SANITARY SEWER PROFILE (A-EX.)

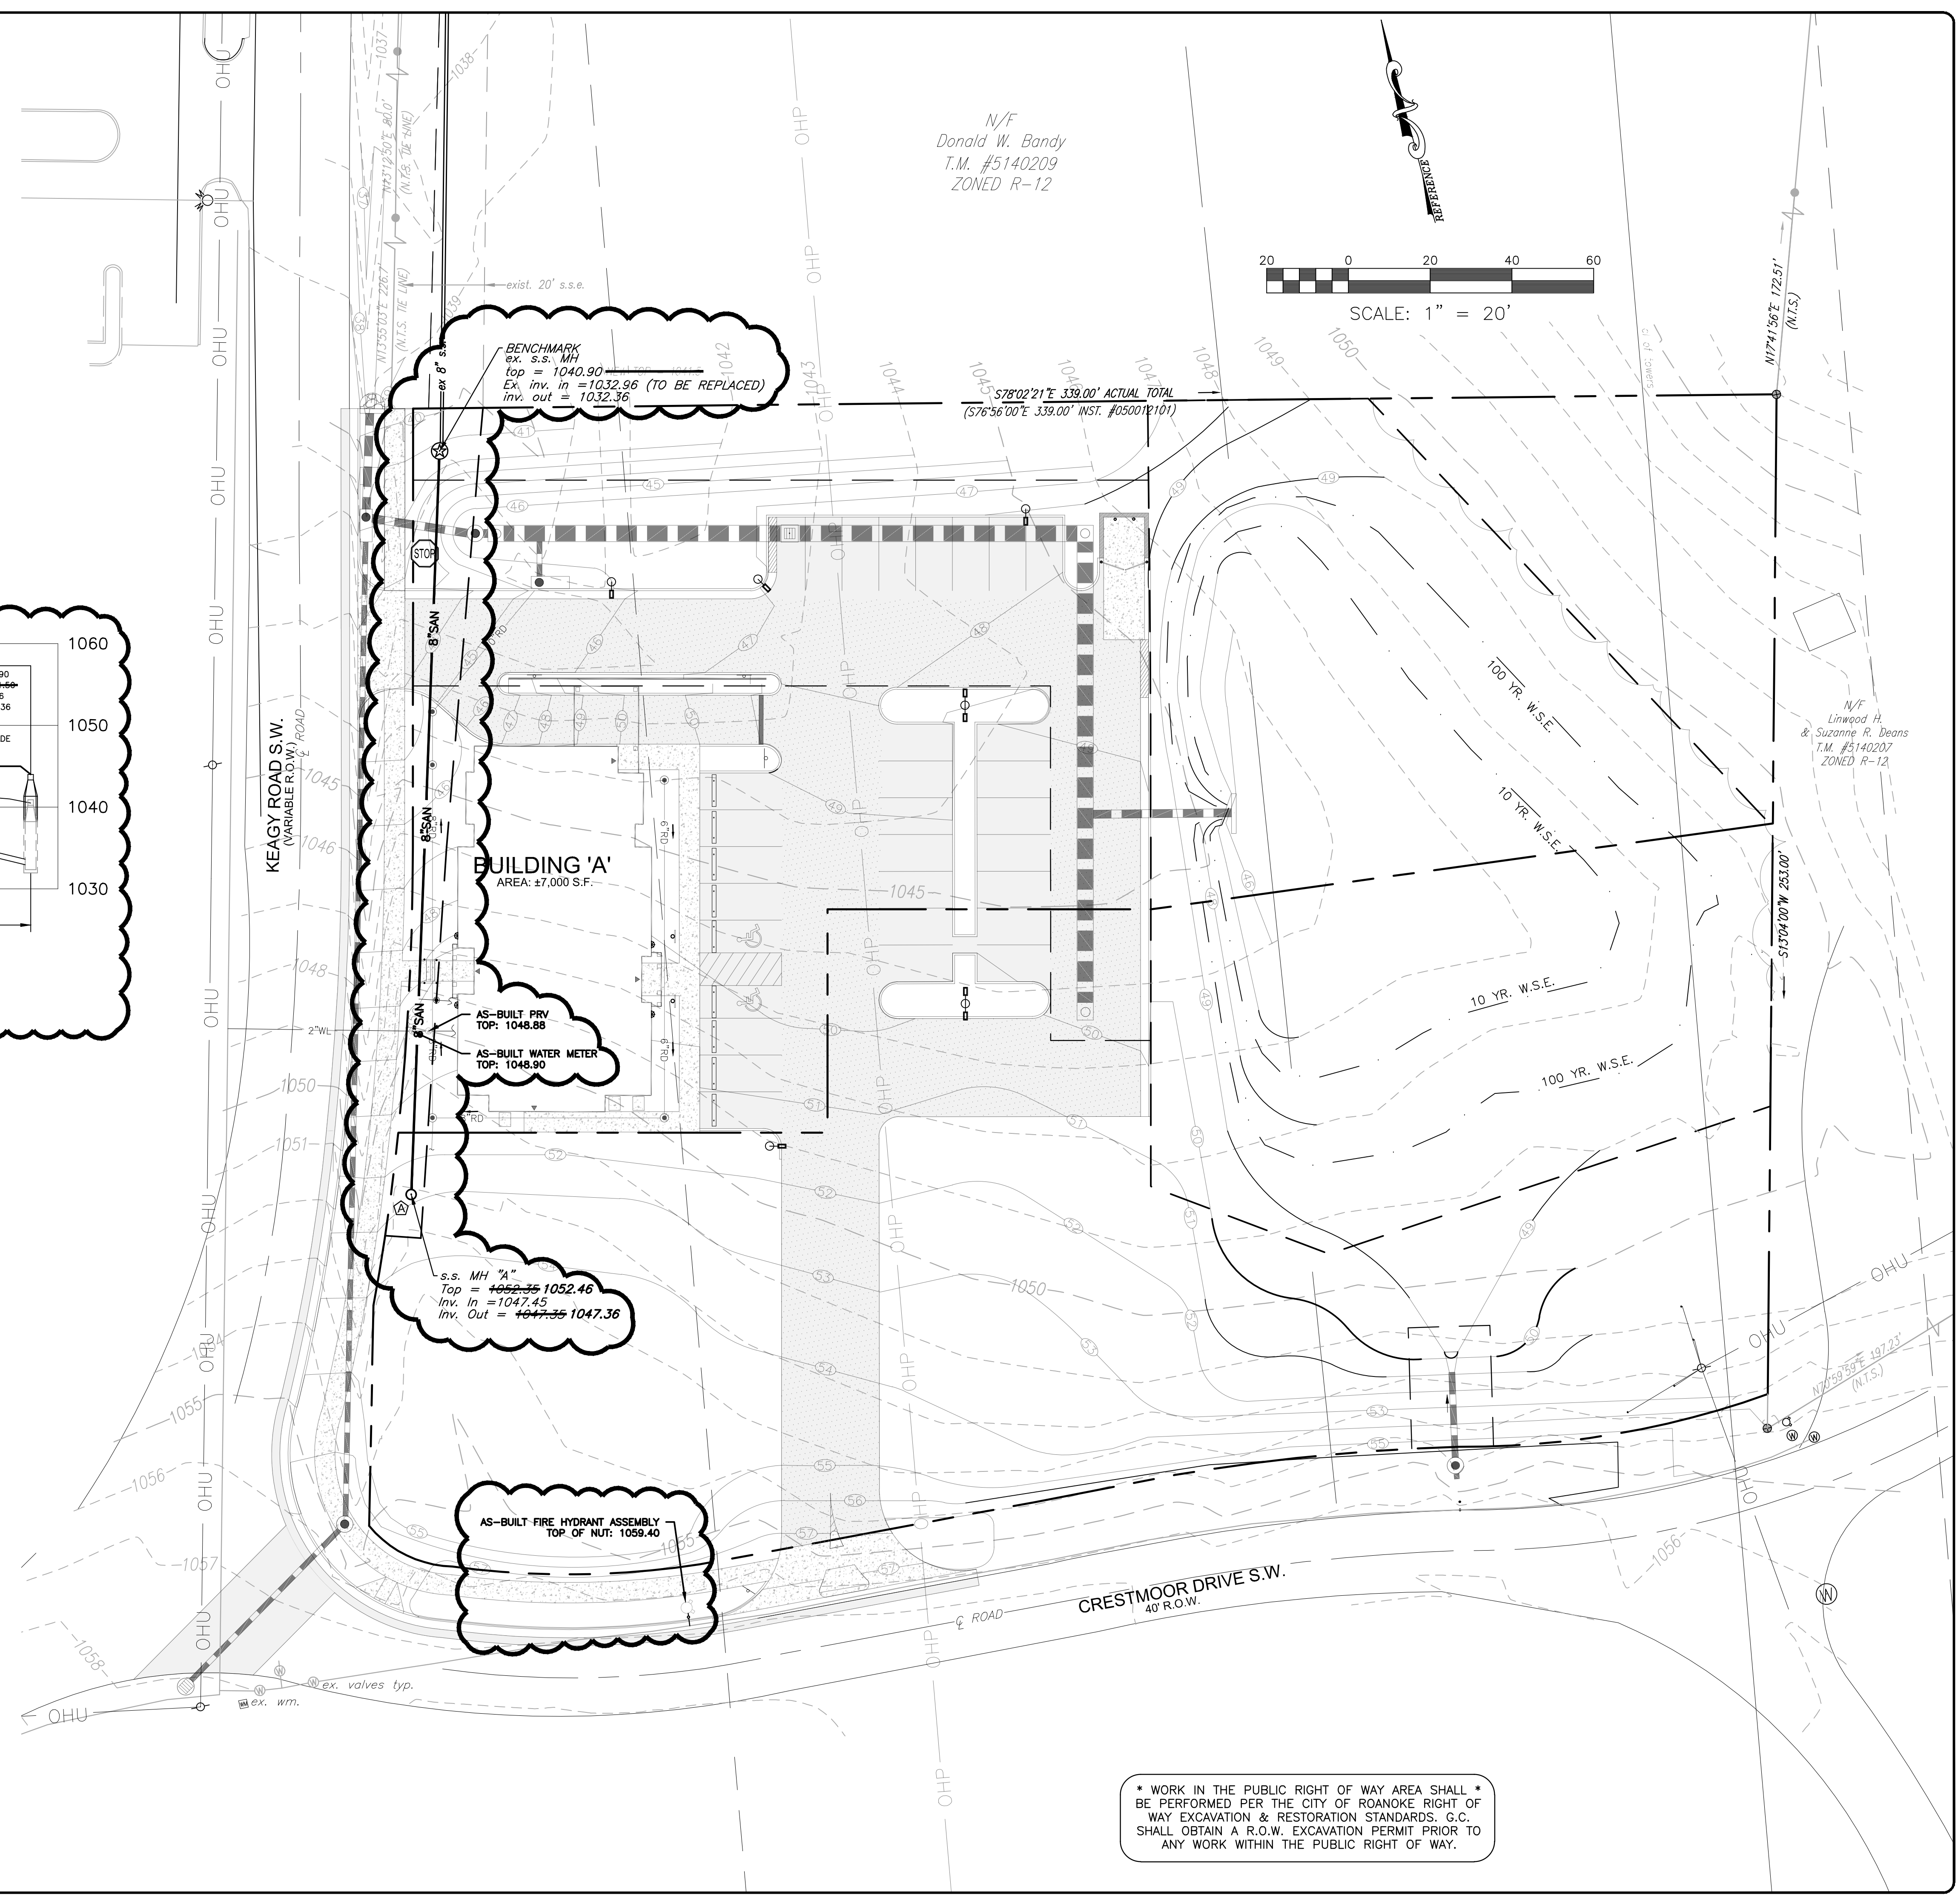
Ex. s.s.m.h.
Ex. Top = 1040.90
~~NEW TOP = 1041.50~~
Inv. In = 1032.96
Inv. Out = 1032.36

(EX)	S.S. MH W/ STANDARD LID EX. TOP=1040.90 NEW TOP = 1041.50 INV. IN=1032.96 INV. OUT=1032.36
(EX) (A)	179 100 LF OF 8" SDR-35 PVC PIPE AT MINIMUM SLOPE OF 7.91% 8.04%
(A)	S.S. MH W/ STANDARD LID TOP= 1052.36 1052.46 INV. IN=1047.45 INV. OUT= 1047.36 1047.36
